SCUTTLE Mechanical Guide

revised 2022.11

Part 1: Mechanical Upgrades

SCUTTLE v2.3 to v2.4

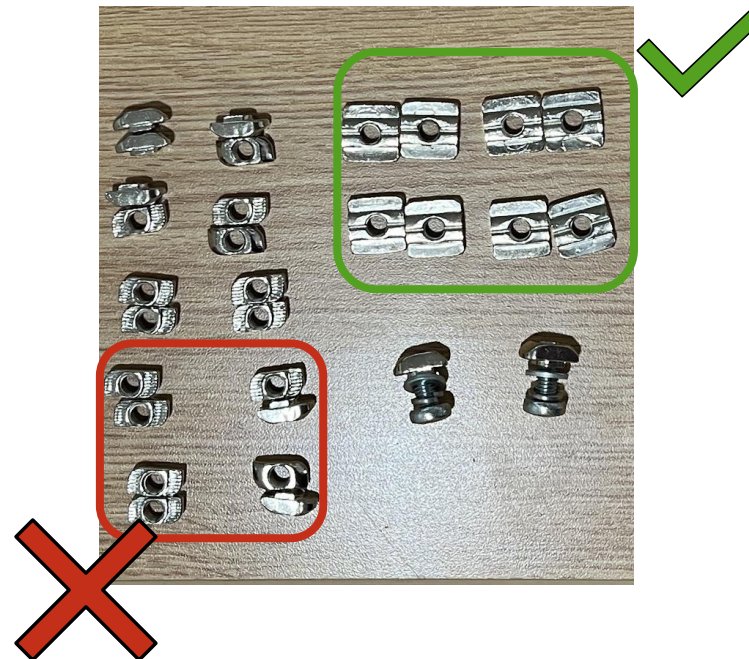
- ▶ Replace 8 drop-in nuts with slide-in nuts
 - ▶ Easier assembly of wheel bracket
- ▶ Increase casters fasteners
 - ▶ From 2 sets to 3 sets per caster
 - ▶ (screw + washer + lock washer + drop-in nut)

Extrusion Cap

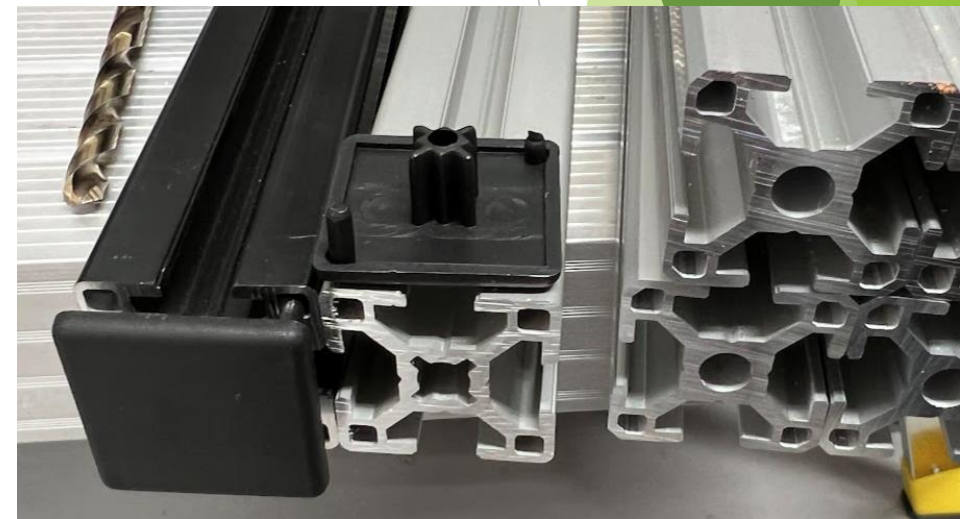
- ▶ Extrusion caps aim to match the extrusion type
 - ▶ Asia: small center hole
 - ▶ North America: large center hole

Mcmaster holes around 7.12mm

AutomationDirect holes around 7.24mm

Caps with "X" cannot fit AutomationDirect Extrusion

2022.04 Wheel Bracket v3.3

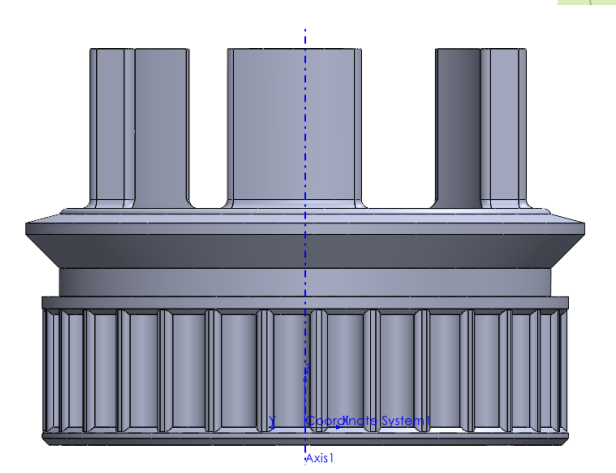
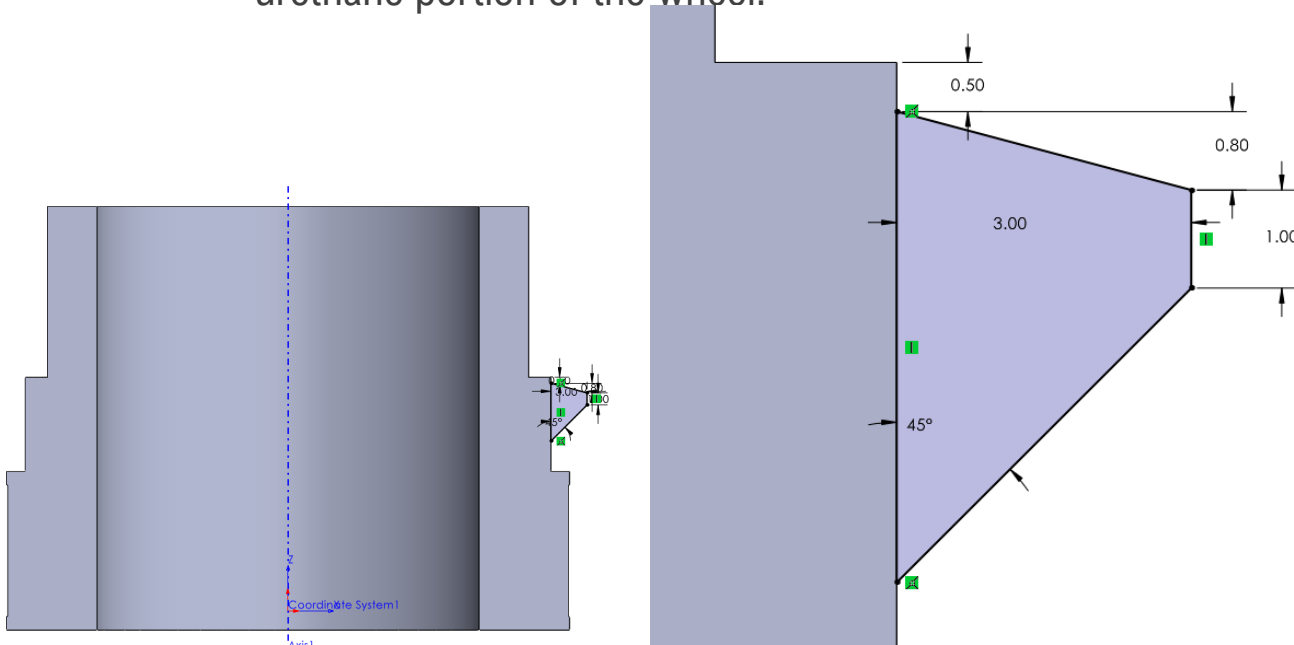
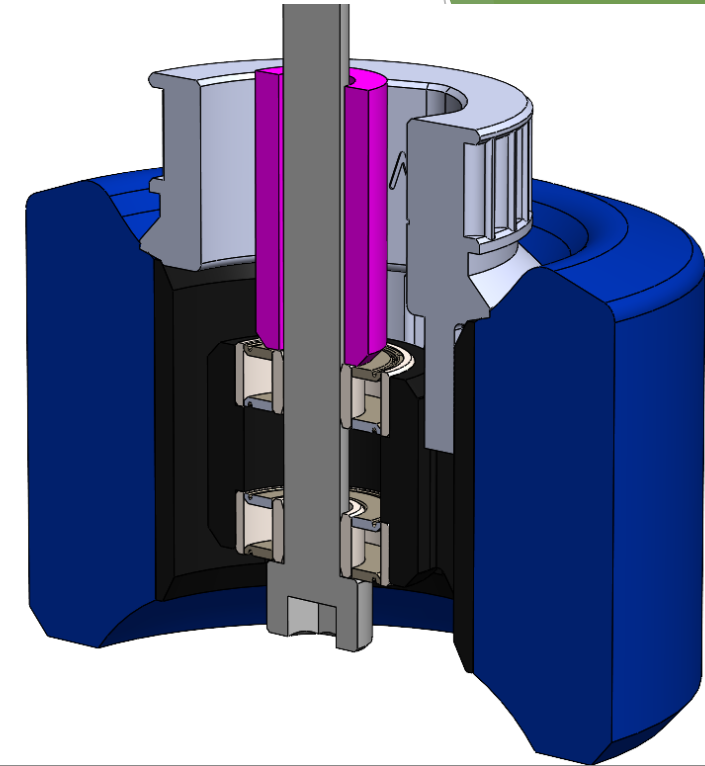
- ▶ Updated from v3.2
 - ▶ Lateral dimension increases from 2.2 to 3.0mm
 - ▶ Increase of the reach of the adhesion face to make more contact with urethane portion of the wheel.

2022.08 Motor Driver Bracket v1.5

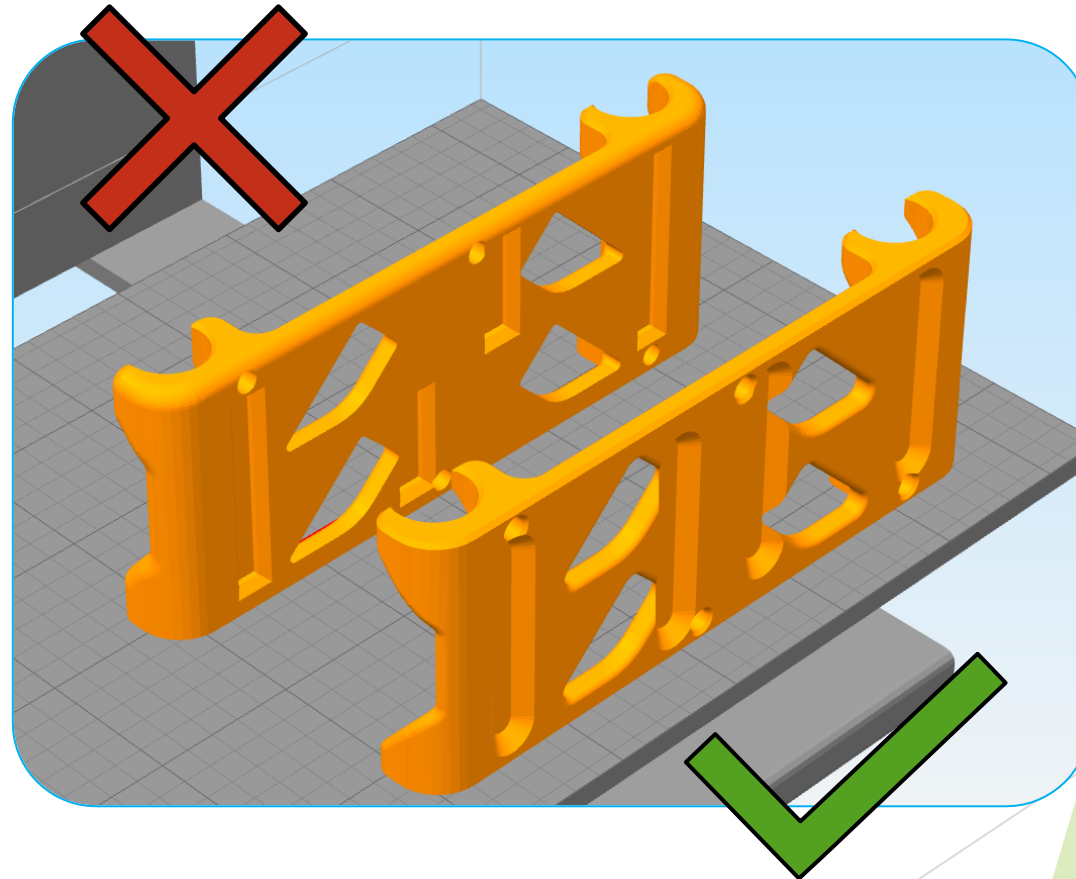
- ▶ Upgrade to v1.5 from v1.4
 - ▶ uses less material
 - ▶ holes chamfered for threaded inserts insertion
 - ▶ improved clearance for motor drivers pins

2022.07 Belt Assembly Countermeasure (pt1)

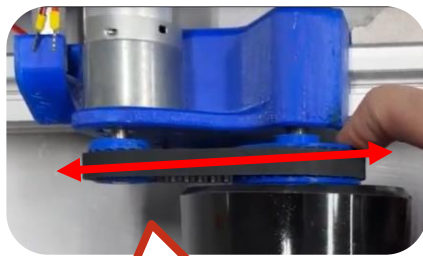
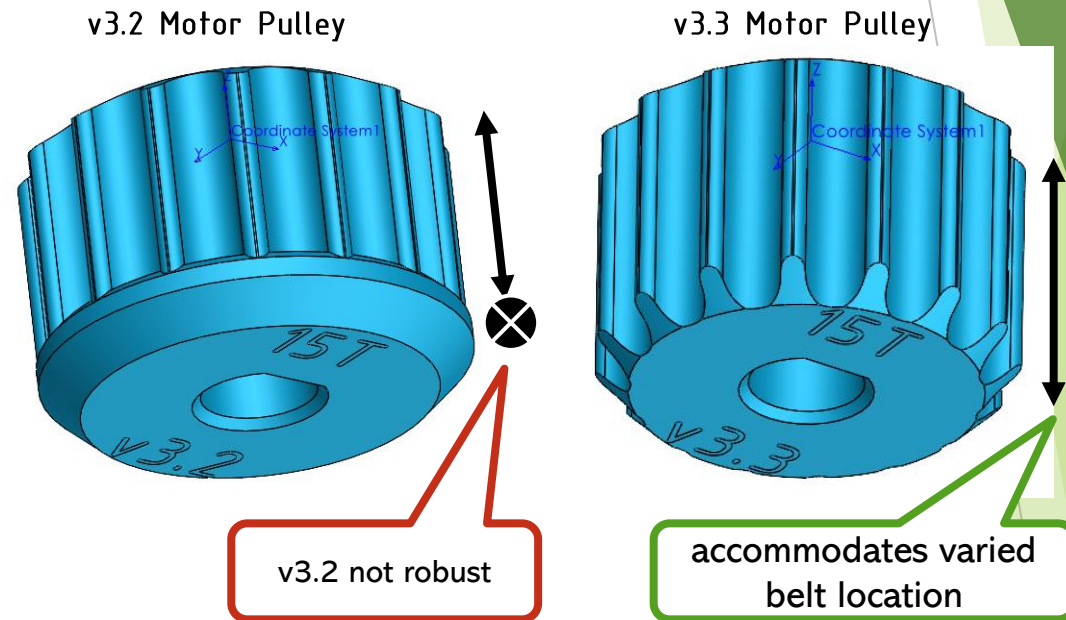
- ▶ Motor Pulley v3.2 updated to v3.3
 - ▶ base shelf is cleared so belts can move when the motor shaft length deviates.
- ▶ DM making countermeasures that eliminate the motor spacer requirement.
- ▶ Belt tension too high when the belt is slightly misaligned.

without CM, belt is misaligned due to longer motor shafts.

2022.07 Belt Assembly Countermeasure (pt2)

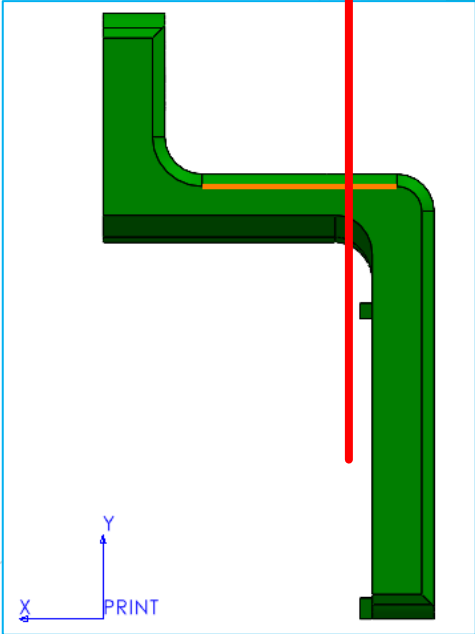
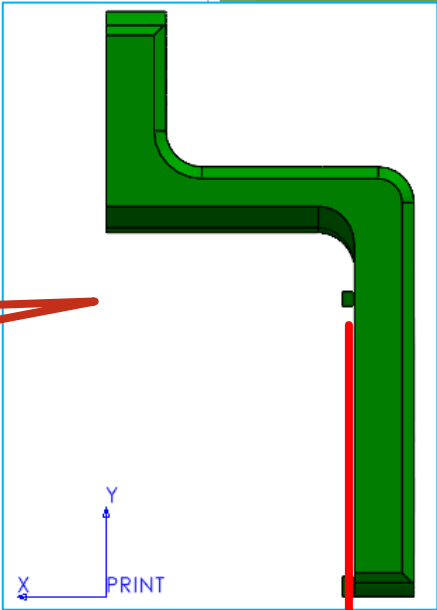
- ▶ Encoder Bracket variant created (v2.8)
 - ▶ reach is extended to accommodate motors with longer shaft.
 - ▶ This is an alternative to motor spacers
 - ▶ This variant is intended for bulk Malaysia motors from summer 2022
- ▶ Requires further verification for full assembly and for all motor variants.

v2.8 gives 21.75mm reach

v2.7 gives 20.75mm reach

2022.06 M3 Screw Selection

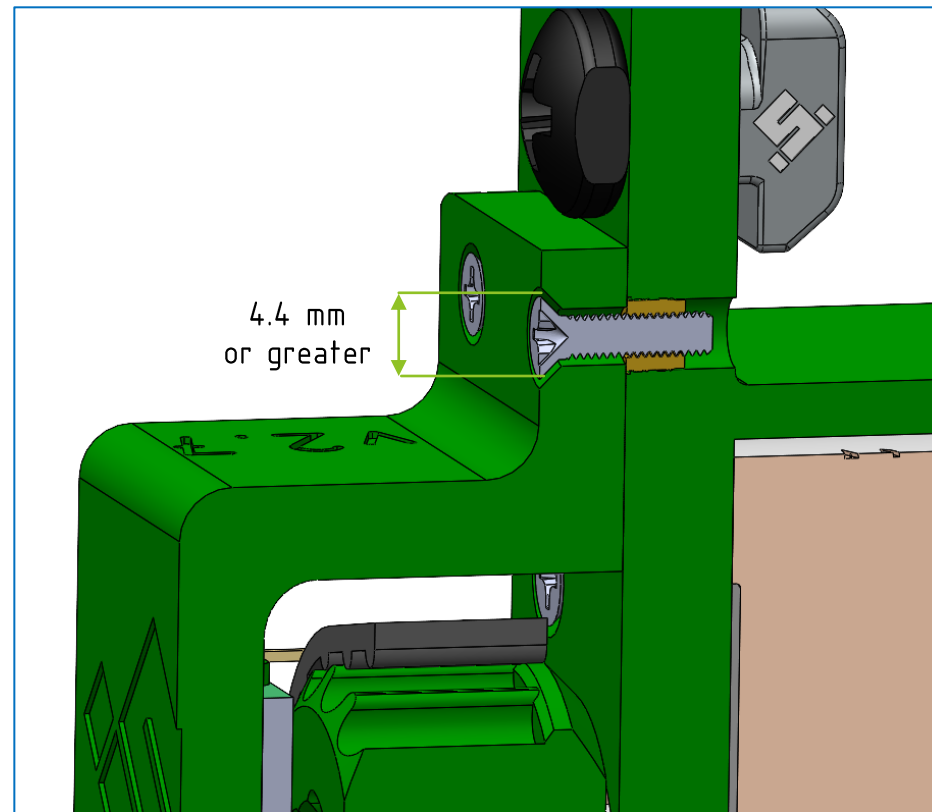
- ▶ Encoder Bracket Screws:
 - ▶ Finer control of the head diameter
- ▶ Next Design
 - ▶ Migrate to flat heads for reduced stress
 - ▶ Update Encoder Bracket accordingly

Motor driver assembly
(isometric, cross-section view)

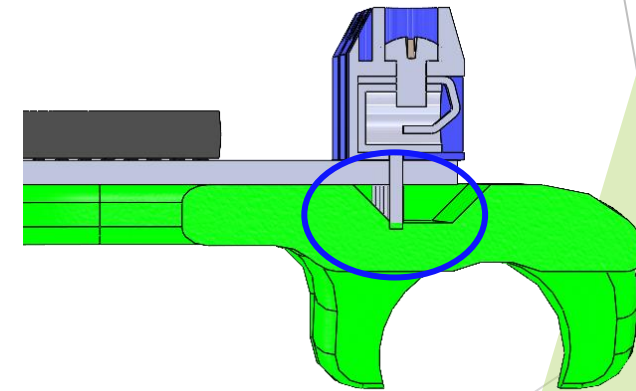
- ▶ Through-hole features on motor driver interfere with the bracket.
- ▶ For Assembled SCUTTLE, we install the motor driver & the pins must have clearance.
 - ▶ Verify the clearance for any assembled units made for demos or customers.
- ▶ If any PCB through-hole pins are contacting a plastic bracket, it is safe to snip the pins flush with the board.
 - ▶ Use flush-cutters to make this cut.
 - ▶ This will not impact electrical performance.

Motor Driver Bracket v1.5
improves clearance from v1.4
